CITY OF FORT LAUDERDALE

DEVELOPMENT REVIEW COMMITTEE

CASE COMMENT REPORT

CASE	UDP-S25044
PROJECT NAME	Residences at Bayview
APPLICATION TYPE	Site Plan Level III Amendment
APPROVAL LEVEL	Planning and Zoning Board, Subject to 30-Day Commission Request for Review
REQUEST	Amendment to Reduce Building Height from 150 Feet to 81 Feet, Increase Residential Units Utilizing Bonus Flex Units from 180 Units to 259 Units Inclusive of 12 Affordable Units, and Increase Commercial Use from 6,590 Square Feet to 8,081 Square Feet
APPLICANT	Sunrise and Bayview Partners, LLC.
AGENT	Nectaria Chakas, Lochrie & Chakas Law, P.A.
PROPERTY ADDRESS	1040 Bayview Drive
ABBREVIATED LEGAL DESCRIPTION	Bay Park Amen 39-47 B
ZONING DISTRICT	Boulevard Business (B-1) District
LAND USE	Commercial
COMMISSION DISTRICT	1 – John Herbst
NEIGHBORHOOD ASSOCIATION	Coral Ridge Association
SUBMITTED	October 23, 2025
COMPLETENESS ISSUED	October 31, 2025
STATE STATUTE 166.033 EXPIRATION	April 29, 2026 (180 Days)
CASE PLANNER	Tyler Laforme, AICP, Urban Planner III

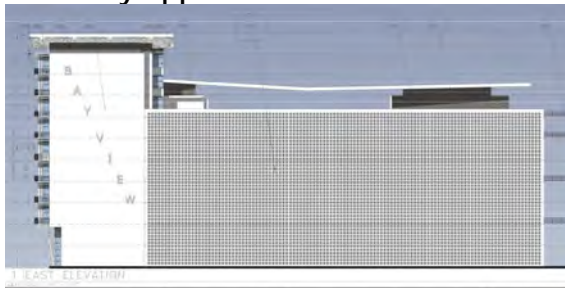
- 6) Provide the following changes on the site plan:
 - a. The building frontage along Sunrise Boulevard is not meeting the setback of 5 feet as the raised terrace is within the setback. A raised terrace is considered a structure and may not be located within 5 feet of the property line at ground level. Shift the building north to accommodate the terrace along Sunrise Boulevard.
 - b. The plaza on the corner does not create an inviting, active or superior pedestrian environment thereby creating a sense of place. The building location should be re-evaluated to provide more ground level space with better pedestrian access into the site with stairs and ramps strategically located thereby creating a more inviting pedestrian environment that integrates with the first floor of the building and with the plaza that is provided on the west side. See image examples below.

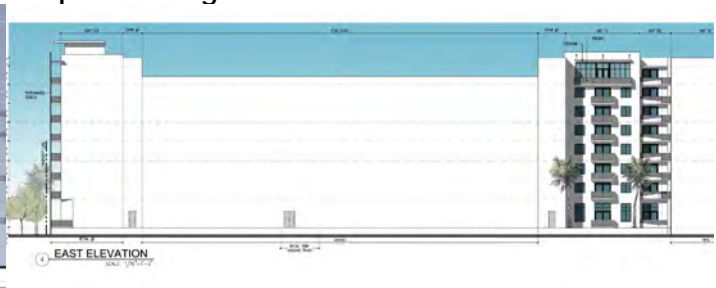
- d. As part of the Planning and Zoning Board approval on the original site plan for neighborhood compatibility and preservation, the garage screening for the parking structure integrated a breezeblock design on the east side that paid homage to the former building located on the site and its Mid-century Modern architectural features. Explain how this project provides that level of compatibility which preserves the character and integrity of the adjacent neighborhood.
